Cherokee Nation **Sallisaw Park Improvements**457959 E. 1118 Road

ADDENDUM NUMBER 01

AD 1.01 C5.0

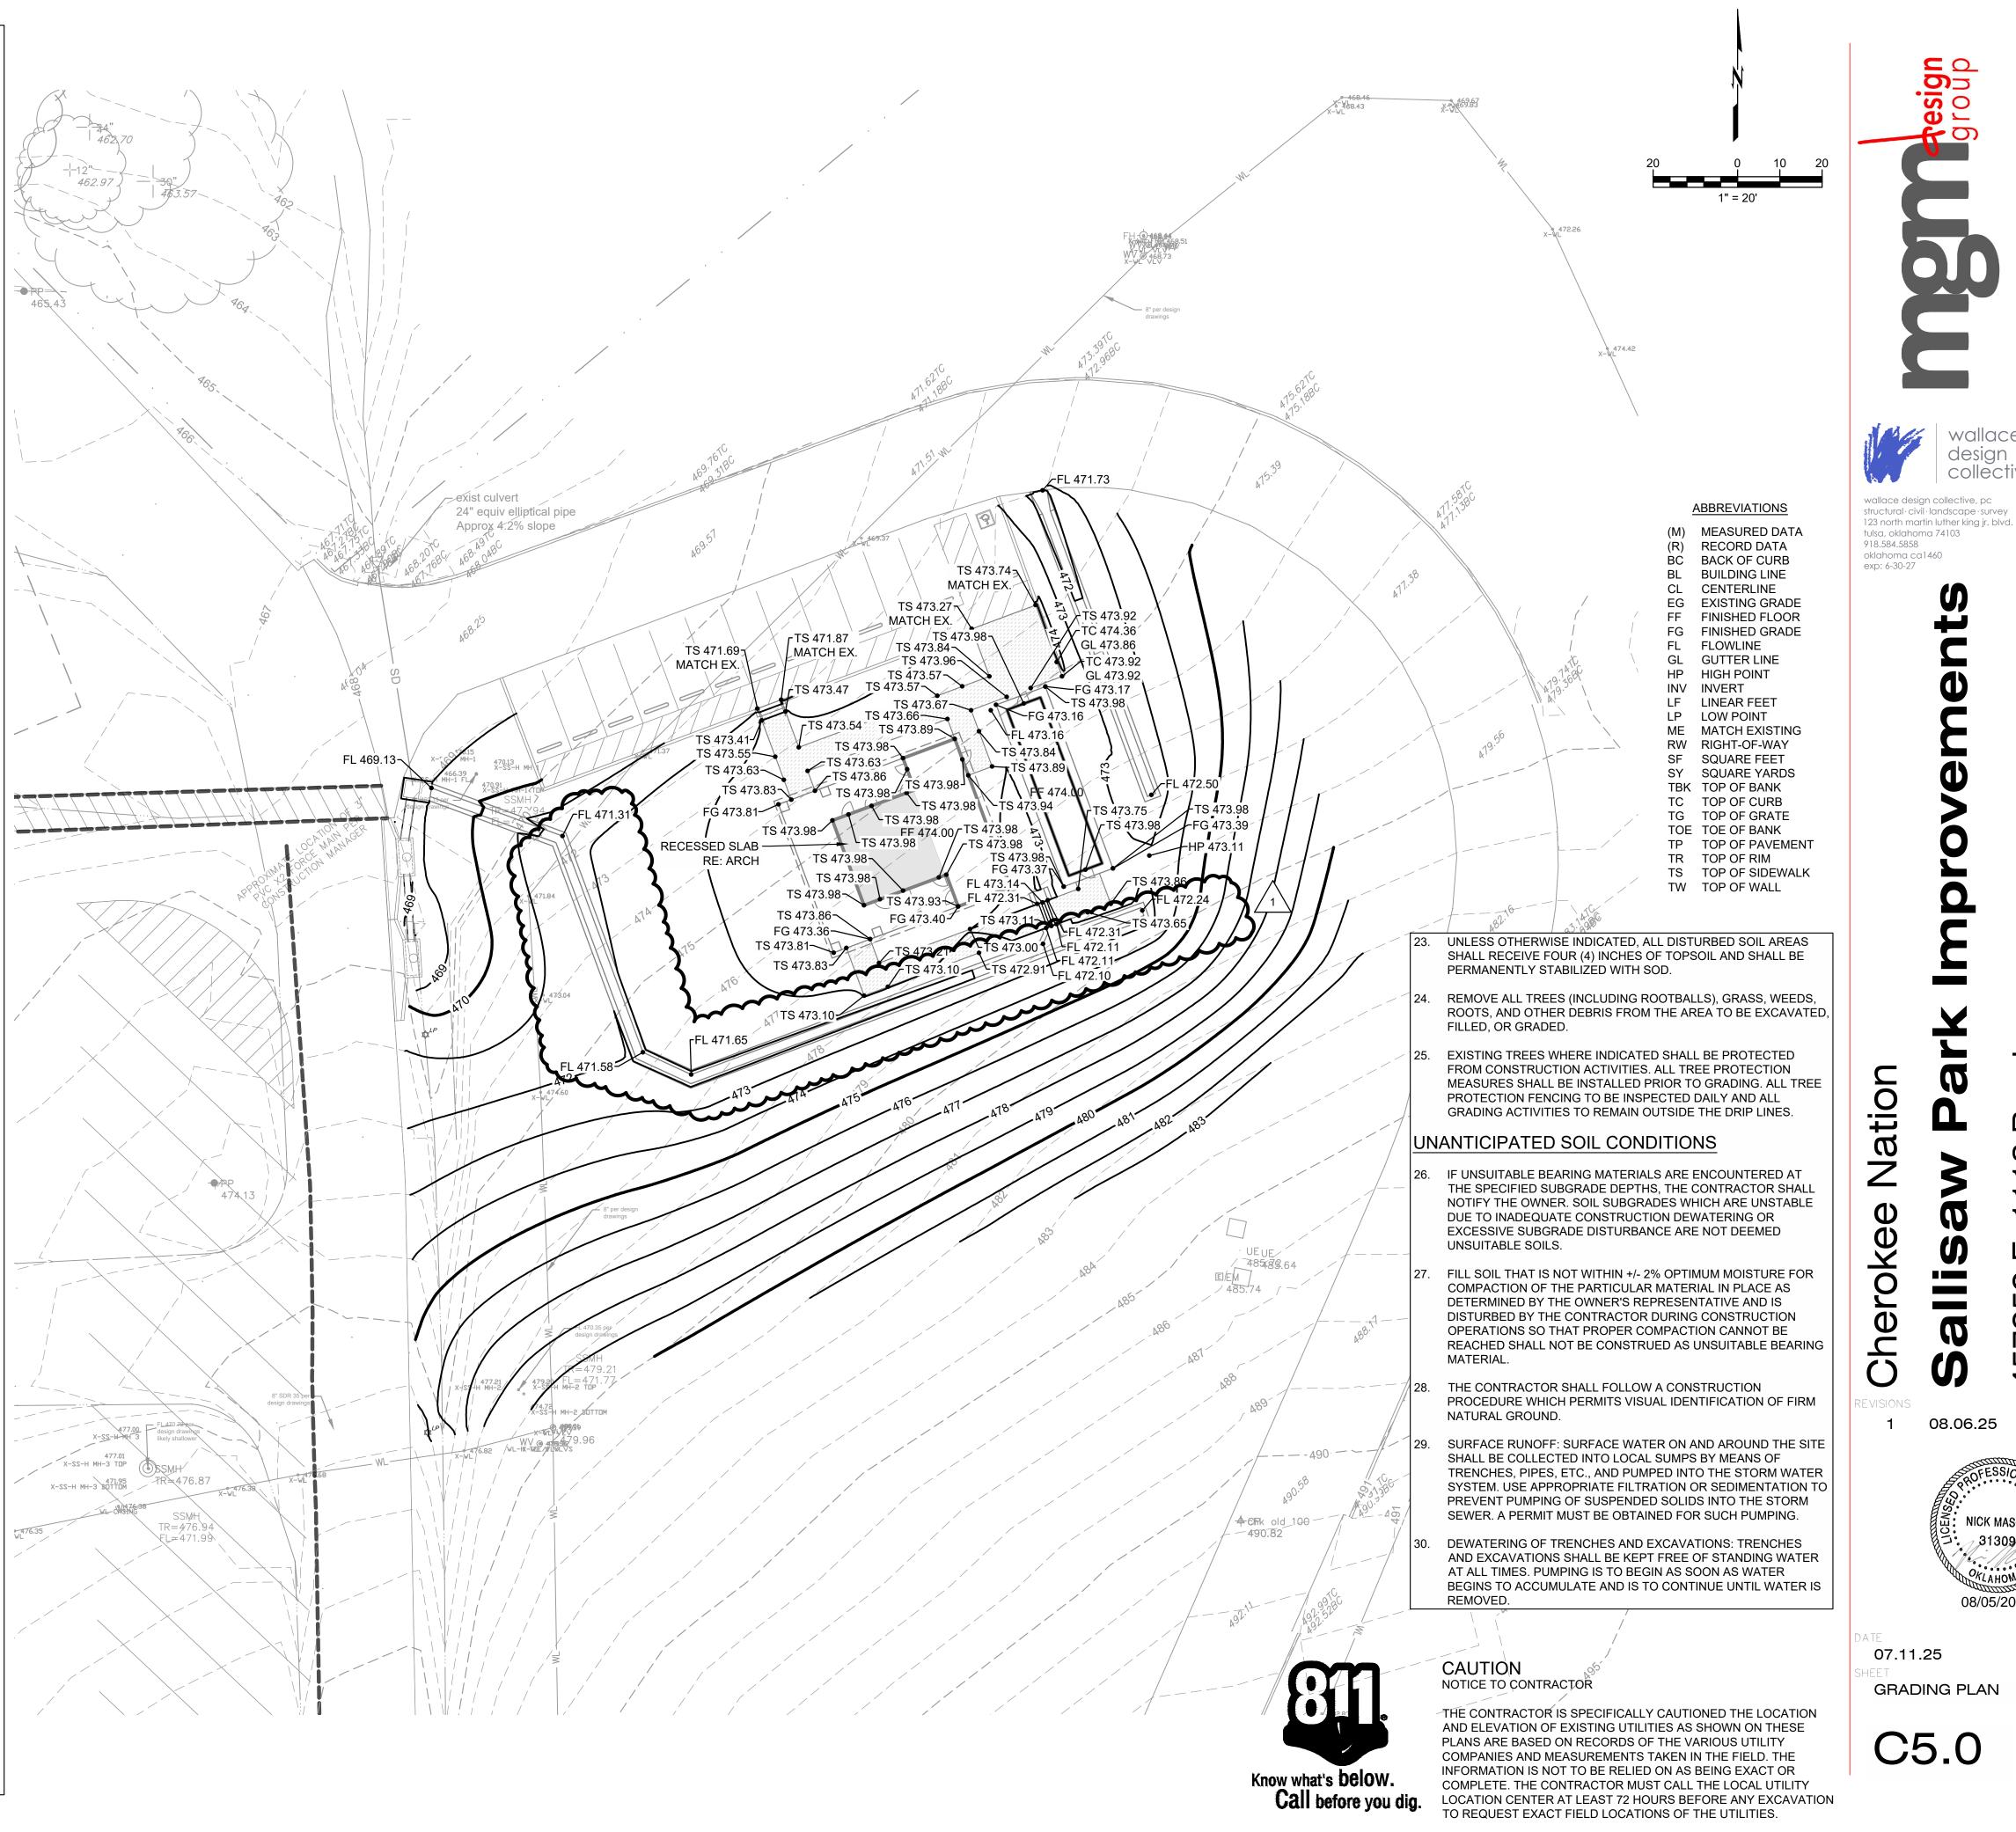
Delete drawing C5.0 and add in its place on attached Drawing C5.0, dated August 6, 2025. (Flume Elevation Update)
